Engine Division

SUBJECT: Prestolite Distributor Housing - Excessive Moisture
and Rust Build-Up

MODEL(S) AFFECTED: All V-8 Gasoline Engines

WITH ROTOR ON NUMBER ONE PLUG WIRE, THE RUBBING BLOCK SHOULD RIDE ON THE DISTRIBUTOR CAM IN THE FOLLOWING MANNER:

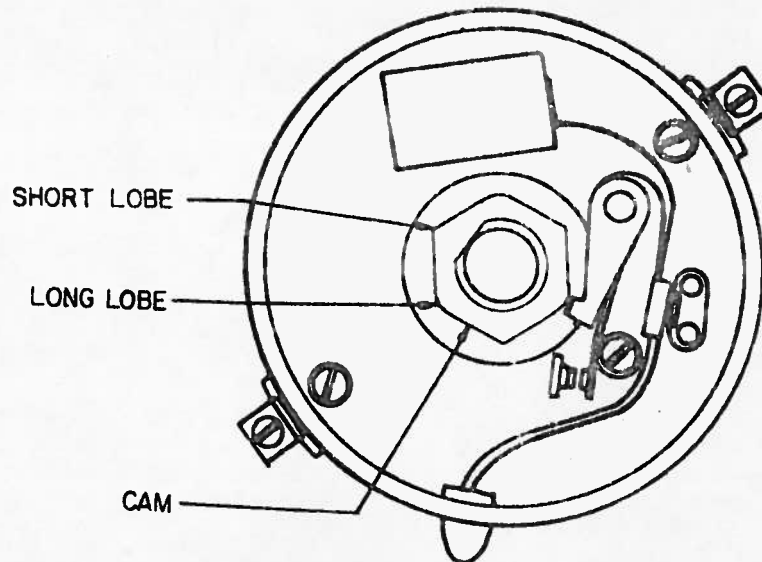
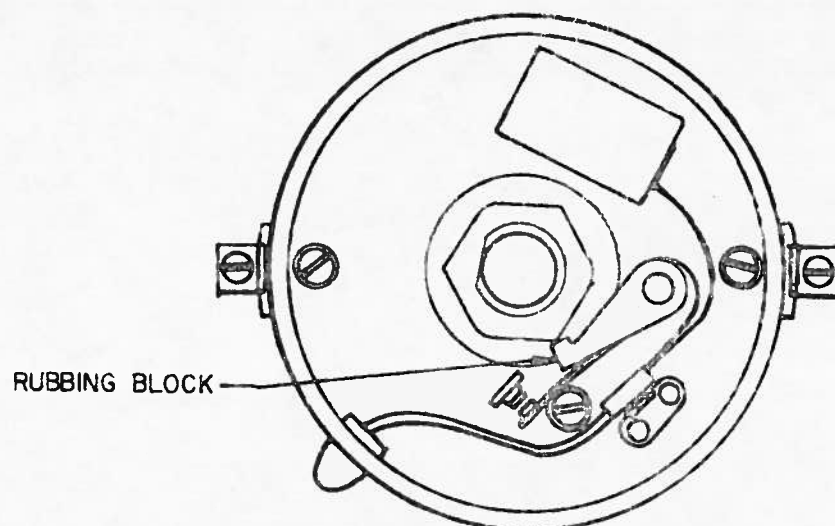
Whenever a distributor is removed it is very important that the proper lobe is used to set distributor timing. (See attached diagram.) The following procedure should be used to install distributor correctly:

1. Set engine timing (#1 cylinder) at T.D.C. static. Note: Make sure cylinder is on power stroke.
2. Install distributor with rotor at 12 o'clock position, as looking at engine from rear.
3. Rotate distributor housing so breaker points open on long lobe of distributor cam.
4. Set point gap at .020 inch.
5. Start engine, check dwell reading and adjust to specification 39° , set timing 10° B.T.D.C. Set idle speed as necessary to obtain 500 RPM in forward gear.

Procedure is the same as for left hand, except step No. 3. Set breaker point rubbing block on short cam lobe to set point gap. Set dwell and timing - adjust idle speed.

SUBJECT: Cylinder Head Assemblies

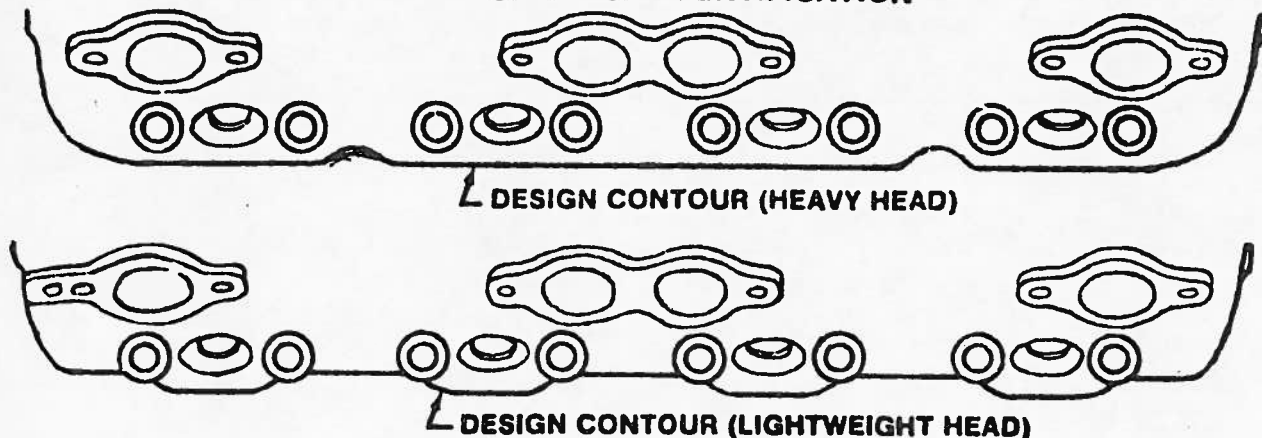
New, lightweight cylinder heads for the above Crusader V-8 engines were released for 1978 production. The new heads are approximately 6 pounds lighter than earlier style heads, due to water passage internal coring changes and slight outer configuration modifications.

Also, the lightweight heads consist of two designs (from differences in the machining of the exhaust valve spring seats). Identify these cylinder heads from the following information:

The cylinder heads can be identified by measuring from the top of the exhaust valve guide to valve spring seat (exhaust only).

If the dimension is .75" (3/4" or 1.91 cm), use 33312 valve spring (1st design head).

If the dimension is .84" (27/32" or 2.14 cm), use 33241 valve spring (2nd design head).

If "lightweight" service replacement cylinder heads of "2nd design configuration" are required for an engine, that is originally equipped with a 1st design "lightweight" cylinder head, new exhaust valve springs (33241) also must be installed (4 required per cylinder head).

In addition, all "lightweight" service replacement "2nd design" cylinder heads use exhaust valves with .372" (9.449 mm) stem diameter. Because of this, when installing a replacement "lightweight" cylinder head on a "190-220", new exhaust valves (33335) also must be installed.

SUBJECT: MOUNT ADJUSTING TOOL PART NUMBER 22165

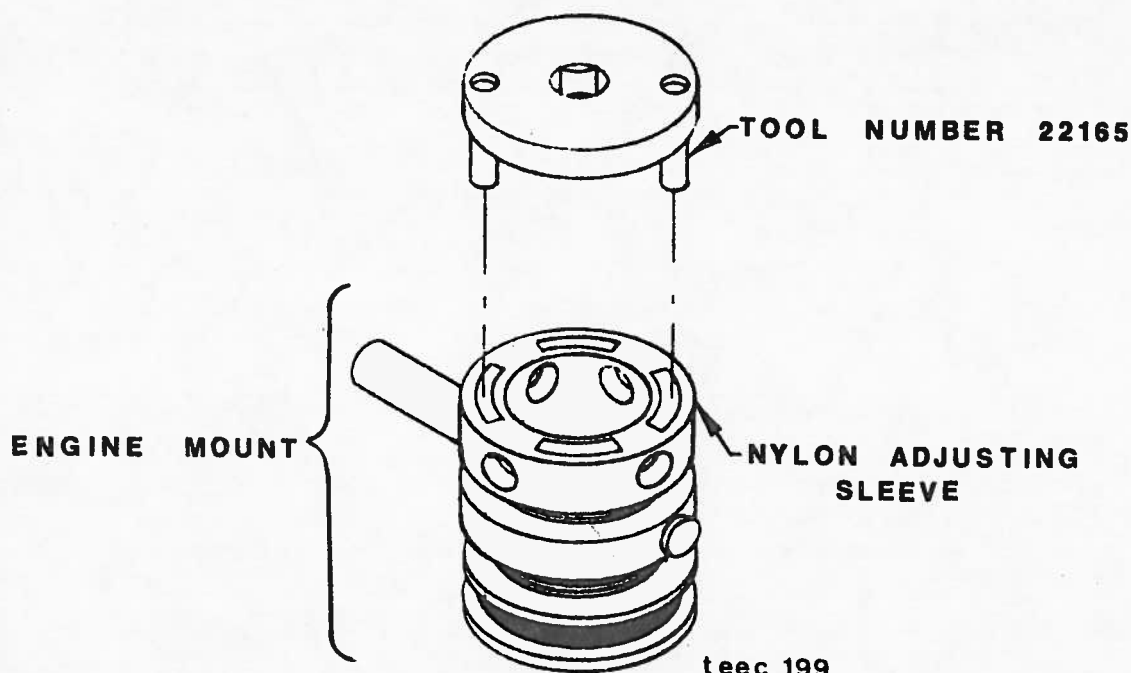
It has been brought to our attention that the nylon adjusting sleeve on the engine mounts have been breaking when making final engine alignment adjustments. We have found this happens most often on applications where there is not sufficient clearance to rotate the nylon sleeve with a adjustment rod incerted through "both" sides of the adjustment sleeve.

A NEW mount adjusting tool (part number 22165) is now advailable from Crusader Marine to correct this problem.

The tool is used by placing it on top of the nylon adjusting sleeve where two drive pins engage the shoulders of the sleeve. This allows the use of a ratchet wrench on applications where working room is limited.

INSTALLATION OF COIL CONVERSION KIT NO. 22308

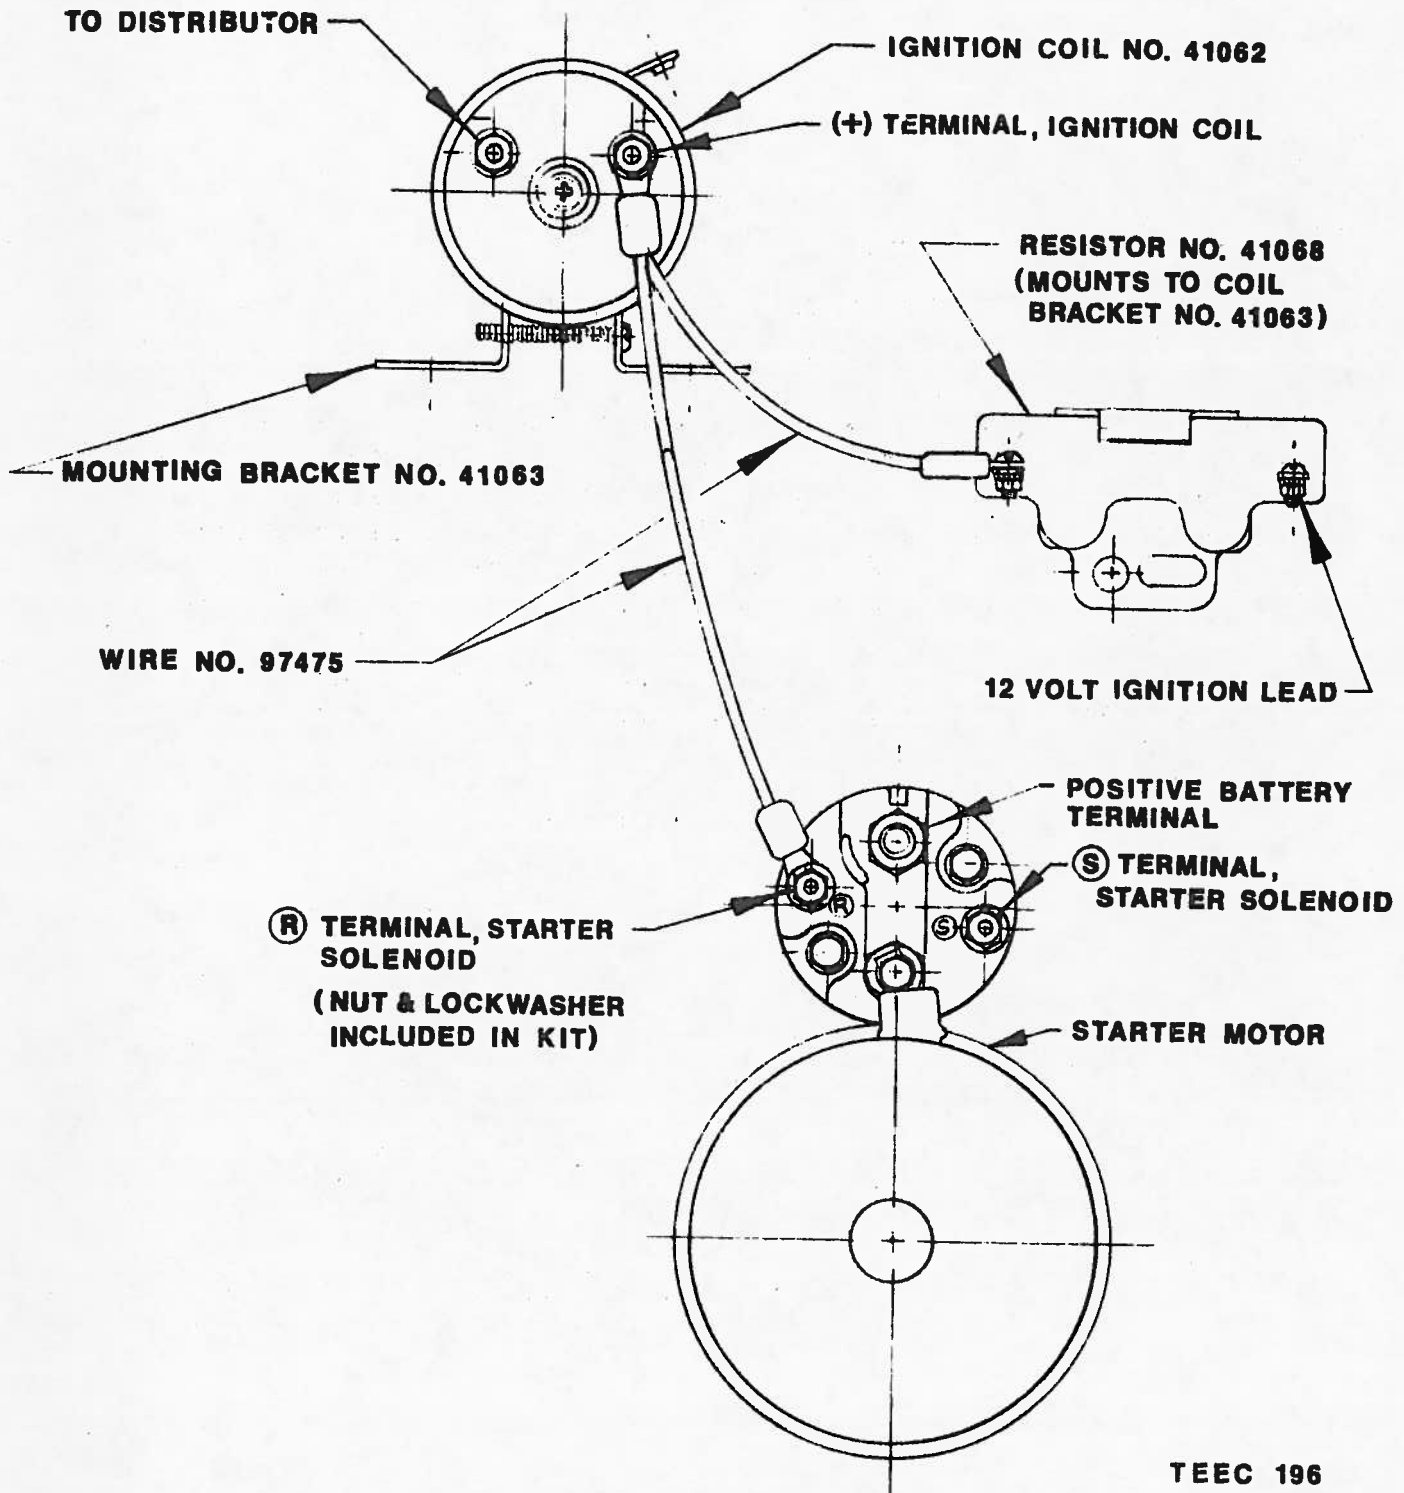
We have noticed some confusion about the availability of the Delco ignition coil, part no. 91412. This coil is no longer available from Crusader Marine. In order to improve engine starting performance we have replaced the 91412 ignition coil with coil conversion kit part no. 22308. The new kit uses a external resistor with a ignition bypass wire from the starter solenoid directly to the coil to deliver a higher voltage in the starting mode only. The kit includes a new style coil with external resistor and all necessary mounting hardware to install on the affected engine.

This kit will replace all Delco ignition coil assemblies. It is further suggested that the complete ignition system be checked and engine tuned-up if needed to further protect against engine starting failure.

Figure 1. Delco-Remy Starter Motor Identification

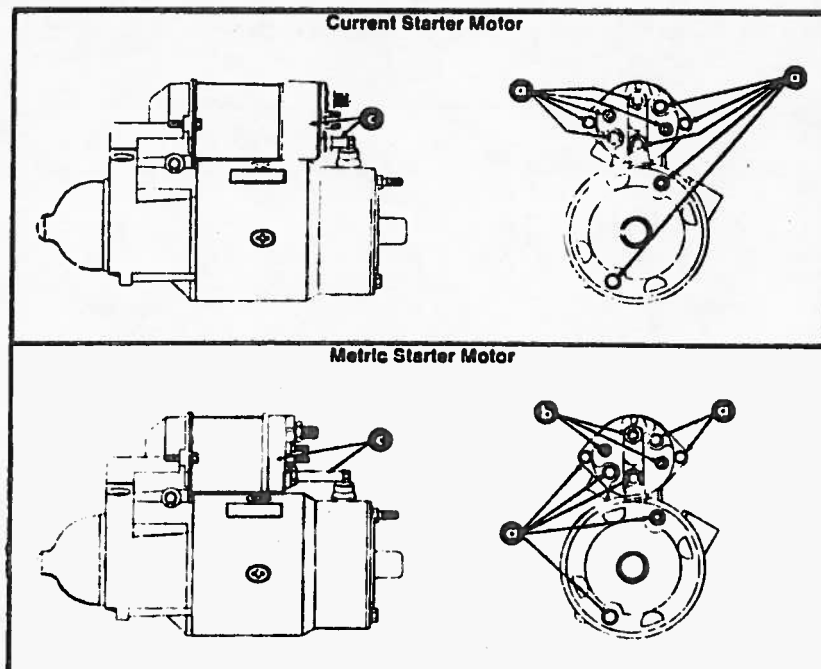
All Crusader gas engines now being built are equipped with new Delco Remy "metric starter" motors which use metric fasteners and a shorter solenoid. Check the Delco number before ordering replacement parts to assure ordering correct replacement parts, as engines may be equipped with either starter motor.

The new "metric starter" will be used as replacements and will backfit any installation which used the standard Delco Remy starter motor.

Figure 1

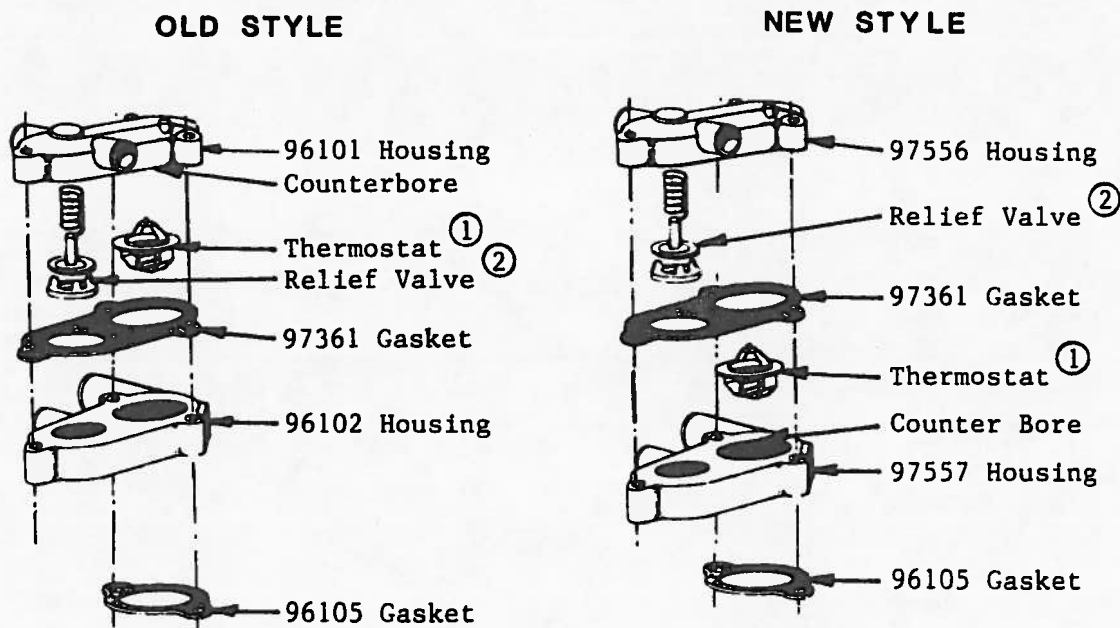
To make installation of the thermostat easier the counterbore for locating the thermostat assembly has been moved from the upper cover to the lower thermostat housing. Whenever replacing one of these components, it is important that the correct housing be installed to insure proper thermostat location as old and new style housings are not interchangeable and must be serviced with correct thermostat top cover. To identify which style is on engine, visually check location of the thermostat counterbore and order the correct replacement part shown below:

4" RISER INSTALLATION

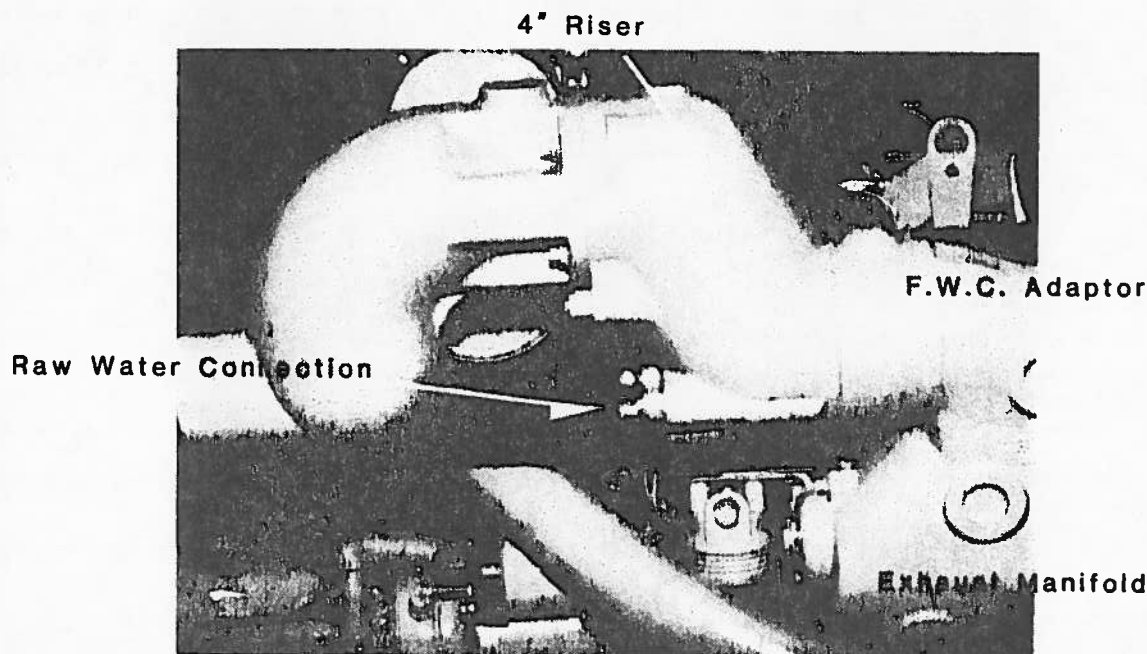
A new 4" riser has been developed and released to production which will standardize all fresh water cooling installations. The new riser is no longer part of the F.W.C. system, as in the past. This new riser is now raw water cooled as are the 8" and 12" risers. This change should stop confusion about the location of the fresh water take-off adaptor which will now be installed between the exhaust manifold and the exhaust riser on all applications.

This change will not affect any raw water cooled applications and will also backfit all previous fresh water cooled engines which used the old style 4" riser, part no. 96419. Interchangeability with older units will not be affected.

Old style riser (part no. 96419) cannot be used to replace 4" riser no. 97772 in fresh water cooled installations, but will work as a replacement on raw water applications only.

**A-C FUEL FILTER CONVERSION KIT #22378
FOR 229 C.I.D. V-6 ENGINE - MODEL 165**

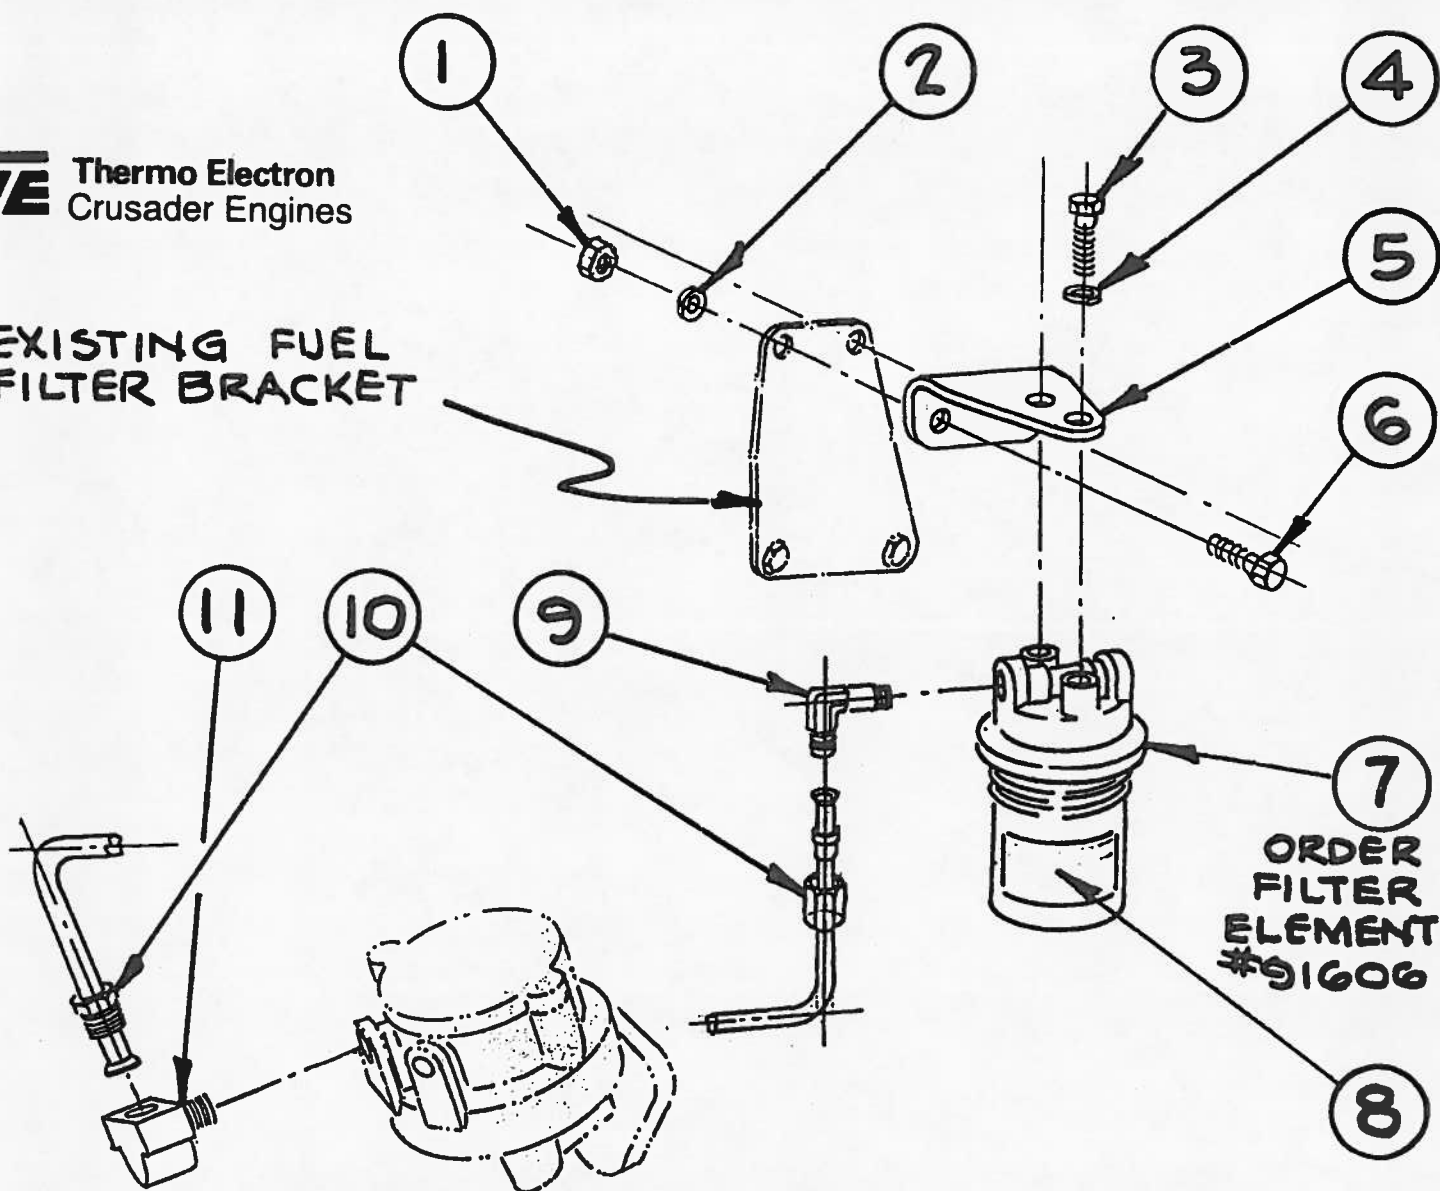
In some engine applications it has been found that the standard fuel filter has not performed up to specification, thus allowing certain types of foreign material to pass through to the carb filter and cause a fuel restriction, leading to poor idling and/or loss of W.O.T. operation. This material is silicones, waxes and strands of glass used in the construction of fiberglass boats and most notably, fiberglass fuel tanks.

When dealer service people are checking out the above complaint, they are finding the bronze filter in the carb restricted. In that they can't see any foreign material on the filter, it is then mistakenly thought the problem is the bronze filter itself and therefore removed and not replaced. This is IMPROPER! In these applications the bronze filter is working and catching the material which is passing unrestricted through the primary filter.

To correct this problem a fuel filter conversion kit has been developed to replace the original filter. The kit consists of new fuel filter assembly, fuel line and filter bracket. The new filter will catch the material used in fiberglass production.
